Schneider AG

### Service - Info

Unit type : Chassis DTV 101

No.: 207

No.: 211

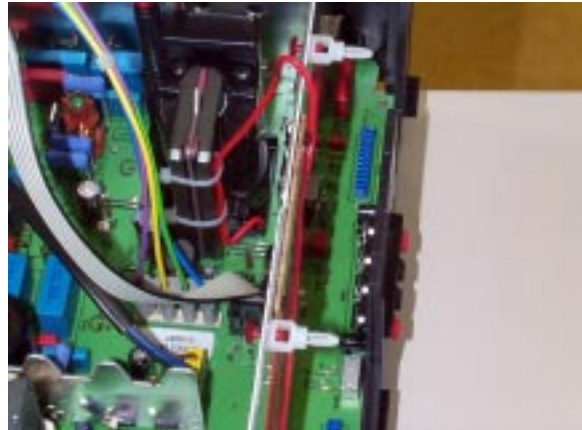
Reducing of vertical shadows by dark video informations.

- ① Change the frame clamp at the right side of the screening from the signal P.C. board through a fixed short ground connector. Solder in a second fixed short ground connector from the left side of the signal P.C. board screening to the frame of tuner.
- ② Control the compensation cable and fix it like the illustration:

The compensation cable, which is soldered in at pin 7 of the diode split transformer, has to be passed through the hole at pin 1 to the ferrit tube. The compensation cable has to be fixed with two cable ties in the middle of the ferrit tube, runned between the cooling shield and the screening of the signal P.C. board and soldered in at the frame of tuner.

**Attention:** To reduce the vertical shadows, the compensation cable has to be layed correctly.

No.: 213

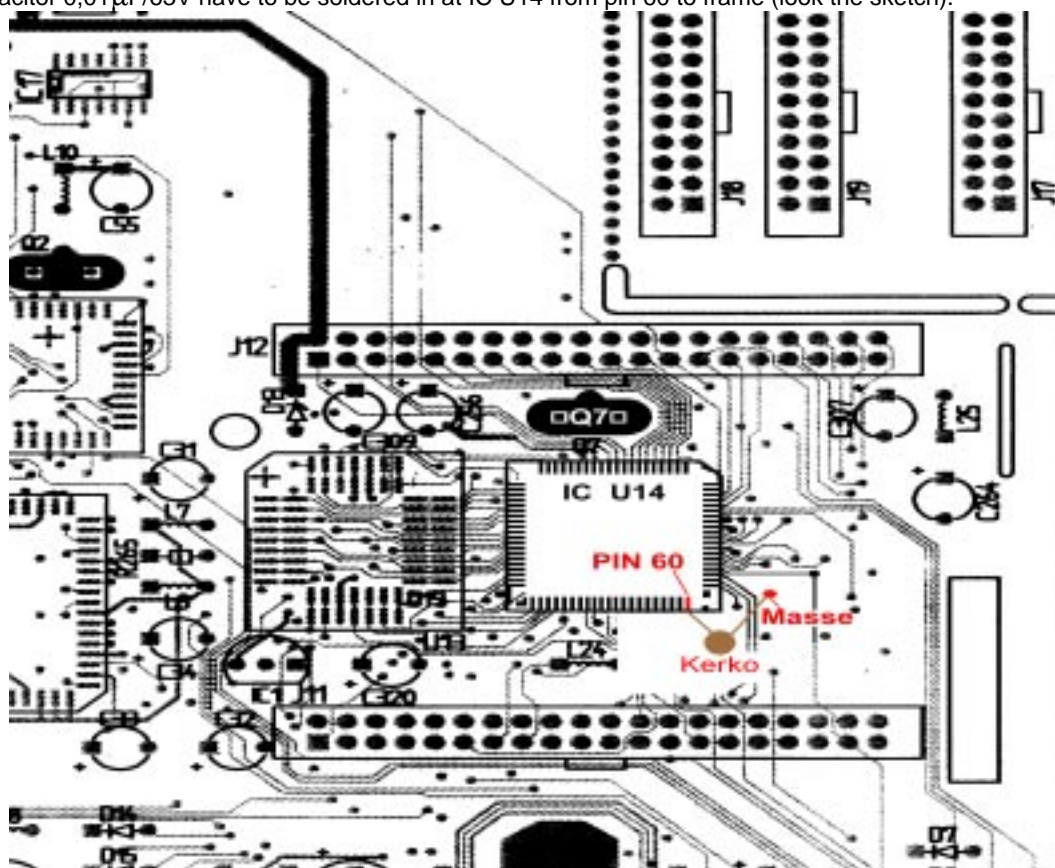
Disturbance at channel 4

- A capacitor 0,01 $\mu$ F/63V have to be soldered in at IC U14 from pin 60 to frame (look the sketch).

No.: 214

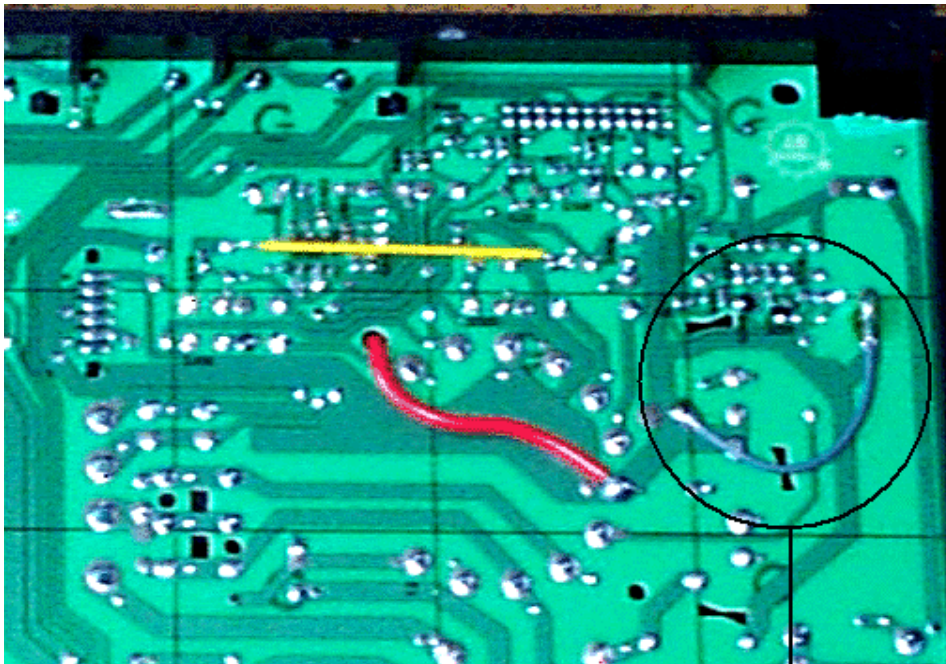
Vertical interference pattern

Extra frame connection cooling plate deflection (see illustration)
